**OFFICIAL COORDINATION REQUEST FOR  
NON-ROUTINE OPERATIONS AND MAINTENANCE**

**COORDINATION TITLE-** 20LGS16 Powerhouse Roof Repair

**PROJECT-** Little Goose Lock and Dam

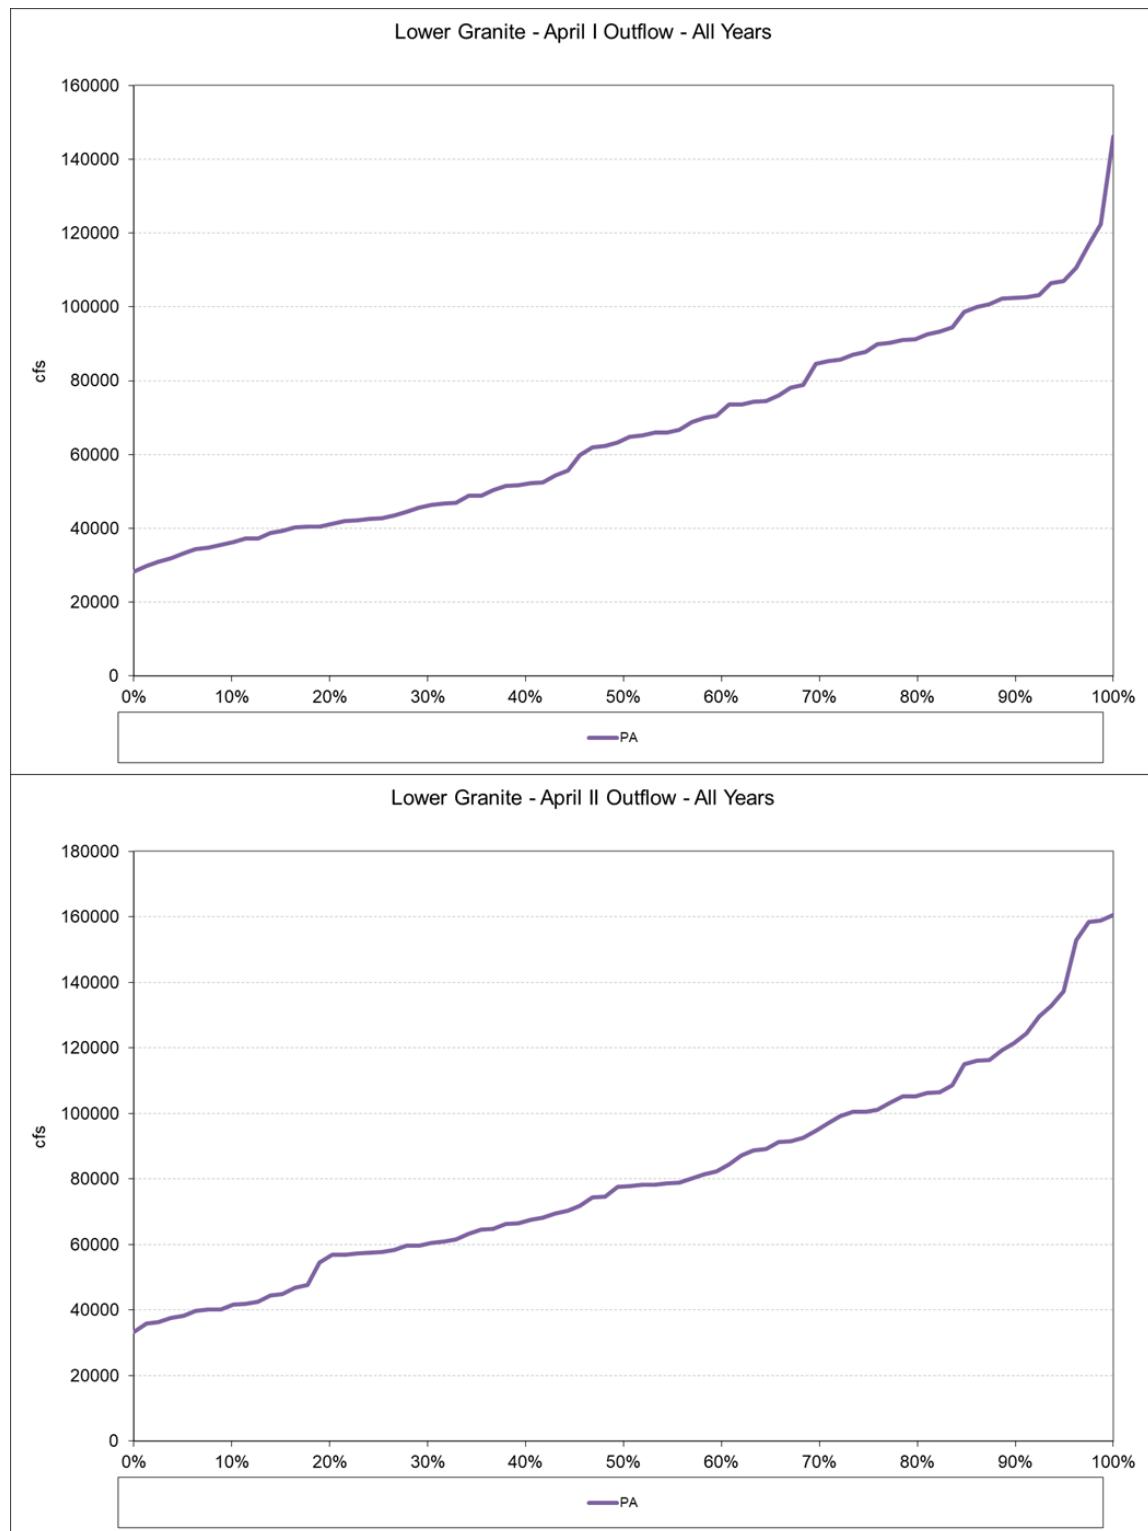
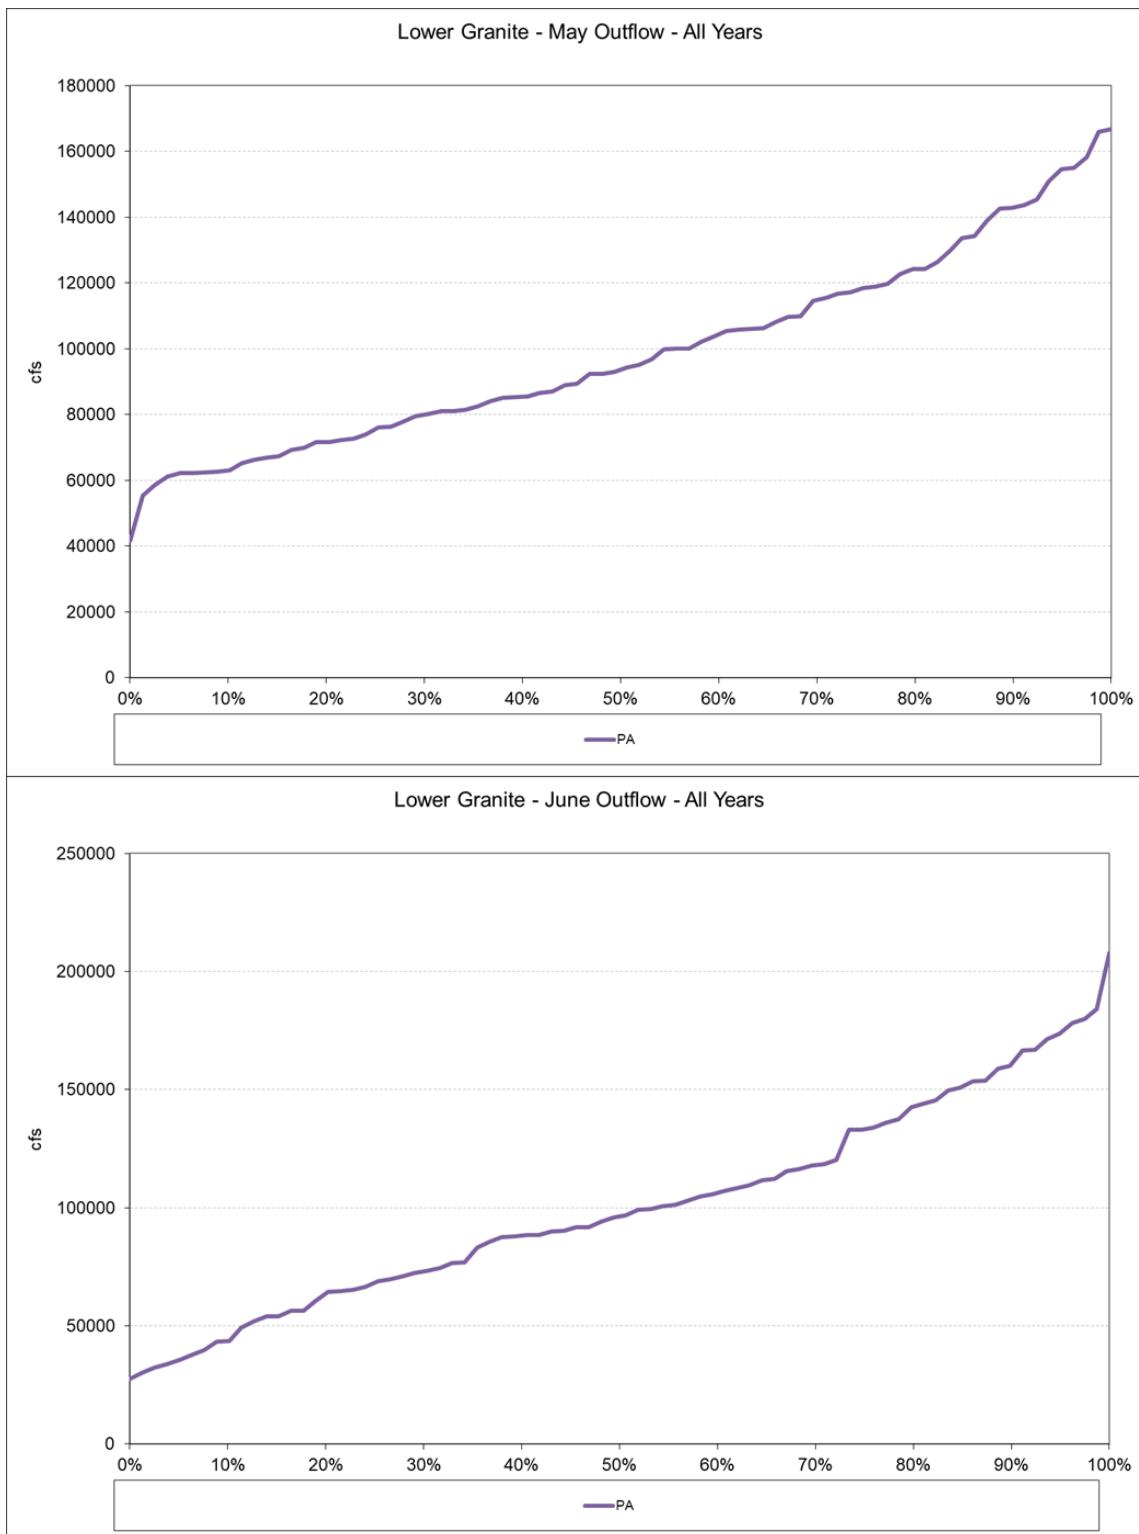
If July isn't acceptable for the four day complete powerhouse outage we could try doing it in early April. At that time all the spill could benefit juvenile fish and there are very few adults are passing. The only downside of doing it then is that the powerhouse would only have 4 units instead of 5 available. Unit 5 is down for another year so that's why it's only one less unit over the current situation. That would mean the powerhouse would be able to pass 100 kcfs (25 kcfs/unit) and approximately 80 kcfs more through the spillway during the 16 gas cap hours. During the 30% hours it would be able to pass 130 kcfs.

With that capability the project could pass 150 kcfs with 8 hours at performance spill and 16 at max spill. Below are the month average graphs for flow through the Snake. During the month of April flows pick up a lot so that month has been split into two periods. -s
